The Harriet on Riley Park

LOC2025-00133

Submitted:
January 19, 2026

Jennifer Dobbin,
Dobbin Consulting Inc.

REDUCE SHADOW ON PARK

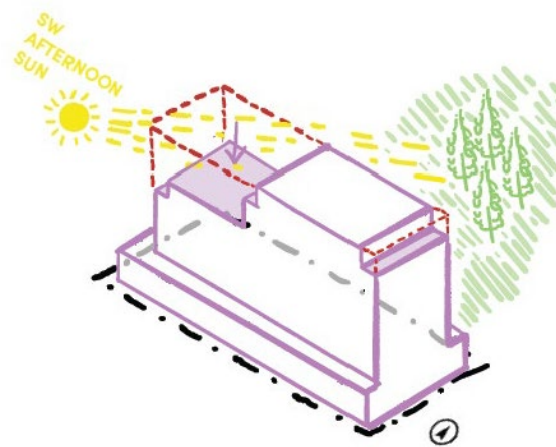
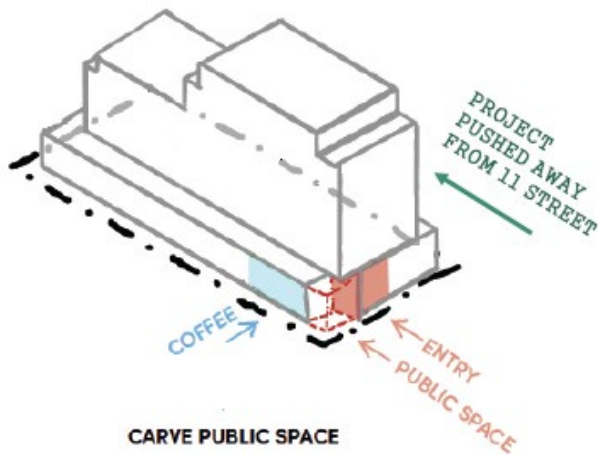
Concerns regarding building height, massing, and shadow impacts on Riley Park were a central theme throughout engagement. In response, the massing strategy evolved from an earlier tower-based approach to a more articulated form that steps from lower heights adjacent to the park up to greater height toward the east.

The current massing places approximately eight storeys along the western edge of the site, increasing gradually toward a maximum of twelve storeys on the east side. This approach reduces shadow impacts on Riley Park, improves transition to adjacent development, and establishes a gateway condition at the eastern edge of the park. This gateway massing is intended to align with future development patterns east of 11 Street NW and anticipated public realm improvements along the corridor.

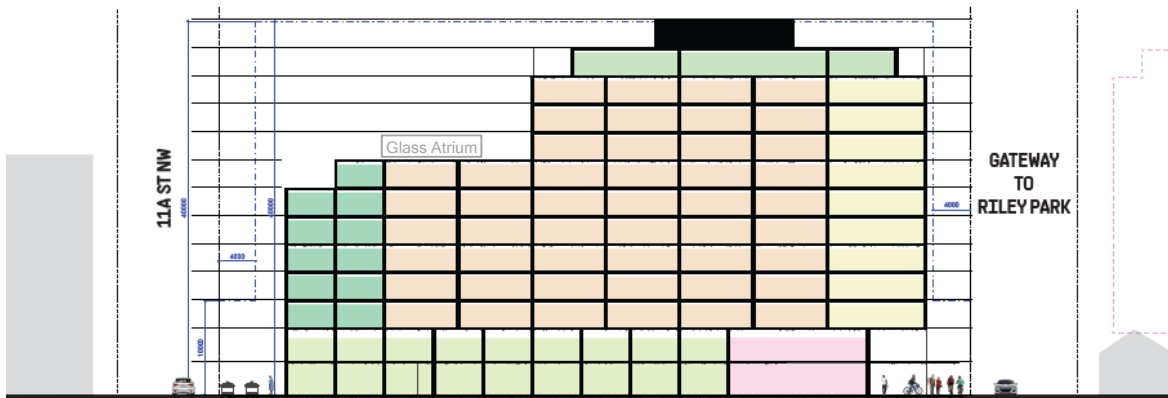
During the second Open House, one participant noted the glass atrium (gym/social area) on top of the eight floor should be noted in elevations and possibly constitutes another storey. The atrium will be glass and significantly set back from all edges on the roof of the eight floor. Elevations will be annotated to indicate this reality.

To address feedback regarding perceived scale and pedestrian comfort, the design respects M-H3 setbacks and incorporates a two-storey podium along public frontages. Upper floors are stepped back to reduce visual mass and improve the pedestrian experience at street level.

Additional step-backs and massing reductions are anticipated as the design advances through the Development Permit stage. These refinements are intended to further reduce shadowing from the upper storeys and create larger outdoor amenity spaces and patios for residents, particularly on upper levels.

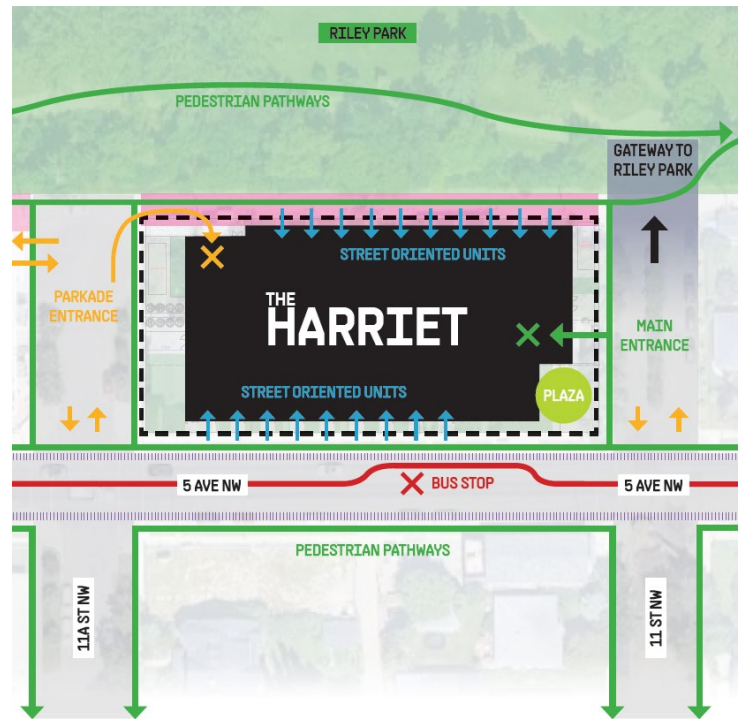
Strong interest was expressed in the quality of the public realm and the role of ground-floor uses. In response, particular emphasis is being placed on the café space at grade, including its interface with the public realm and whether it functions as a commercial or resident-oriented amenity. The main building entrance on the east side is designed to engage a publicly accessible plaza located at the southeast corner of the site, reinforcing activity and visibility adjacent to Riley Park.

The integration of the 5 Avenue NW bike lane, on-site bike parking, and nearby bus stop is being carefully considered through landscape design to ensure a cohesive and safe pedestrian environment.
